MODEL AFFECTED - SUNBEAM IMP

ACTION - MODIFICATION OF STEERING
COLUMN

CAMPAIGN
ACTION

INSTRUCTIONS FOR THE REMOVAL AND REFITTING OF A NEW INNER COLUMN
EXAMINATION OF THE PINION SPLINES AND IF NECESSARY
REPLACEMENT OF THE STEERING UNIT

FIG. 2

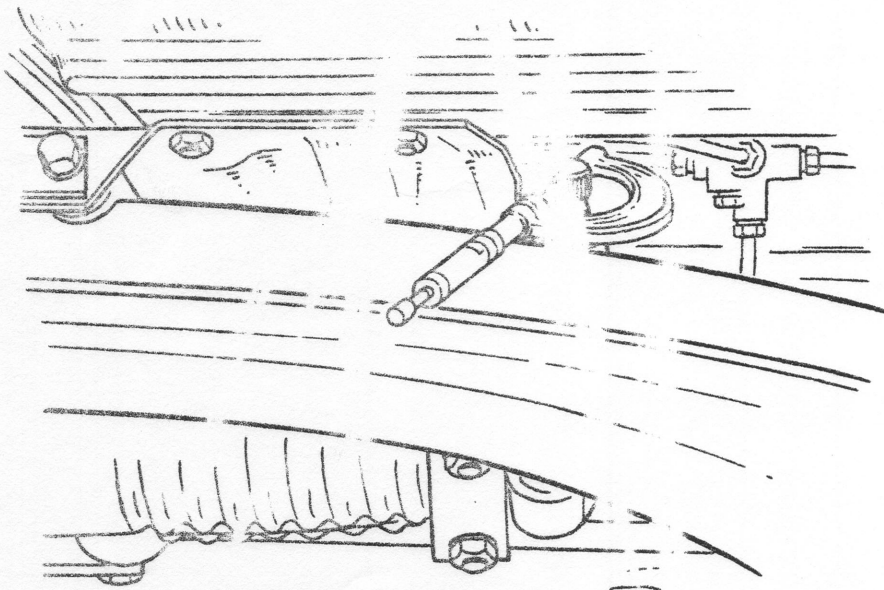
1. Remove the steering unit inner column, having first removed the steering wheel, trafficator pawl unit and outer column.
2. Using a suitable wire brush, thoroughly clean the pinion splines on the rack and pinion unit and then examine splines for any signs of flank wear, corrosion, etc., as illustrated in Fig. 1. If you have any doubt at all as to the condition of the pinion splines, the measurement across the peaks of the splines should be taken in three different positions, using a suitable micrometer as shown in Fig. 2.

The minimum permissible measurement across splines is .550" (13.97 mm).

FIG. 3 A

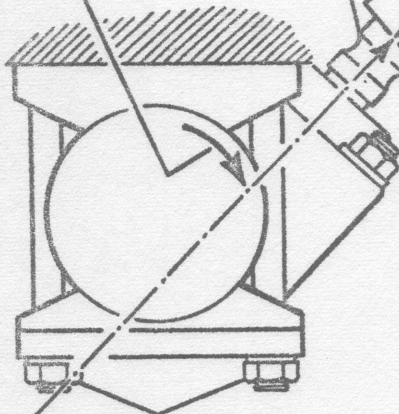
(iv) The rack and pinion unit should be fitted in position, but at this stage the 'U' bolt nuts must not be tightened but left slack enough to enable the unit to rotate. By leaving the nuts loose at this stage, it will allow correct alignment of the inner column to pinion, as shown in Fig. 4. Incorrect alignment is shown diagrammatically in Figs. 3A and 3B.
